Supplement

Manual Title:	DSP-100/DSP-2000 Users	Supplement Issue:	5
Part Number:	642964	Issue Date:	10/02
Print Date:	January 1997	Page Count:	5
Revision/Date:	---

This supplement contains information necessary to ensure the accuracy of the above manual.

Table 3-1. Wire Map Displays

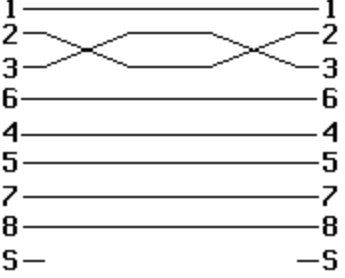
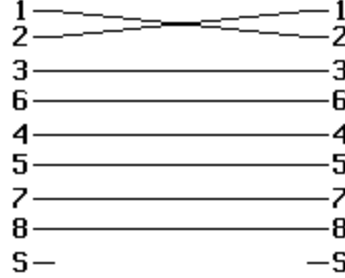
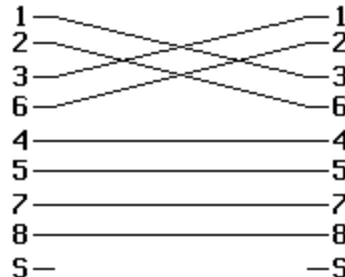
On pages 3-6 and 3-7, replace Table 3-1 with the following:

Wire Map Condition	Displayed Schematic	Description
Correct wiring (Left side of display represents near-end connector.)		Cable wiring is correct. Shield(s) shown only if required by selected test standard.
Crossed wires		A wire in the 1,2 pair is crossed with a wire in the 3,6 pair.
Reversed pairs		Wires 1 and 2 are crossed.
Transposed pairs		The wire pair connected to pins 1 & 2 at one end is connected to pins 3 & 6 at the other end.

Short		Wires 1 and 2 are shorted. You can use the TDR test to locate the short.
Open		Wire 1 is not connected from end to end or "open". You can use the TDR test to locate the open.
Split pair		A wire in the 3,6 pair is twisted with a wire in the 4,5 pair. You can use the TDX analyzer to locate the split pair.

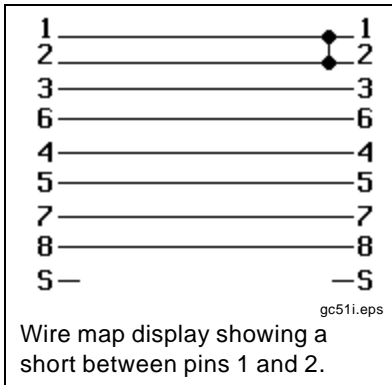
On page 7-23, Table 7-1, replace the entire first column and the bottom two cells of the second column with the following:

Wire map display showing an open on pair 1, 2.

<div><p>gc59i.eps</p><p>Wire map display showing a split pair on pairs 1, 2 and 3, 6.</p></div>	
<div><p>gc47i.eps</p><p>Wire map display showing reversed pair on pair 1, 2.</p></div>	<p>Inspect the color code at each connection/termination.</p>
<div><p>gc49i.eps</p><p>Wire map display showing transposed pairs on 1, 2 and 3, 6.</p></div>	<p>Inspect the color codes of the wires at each connection/termination.</p>
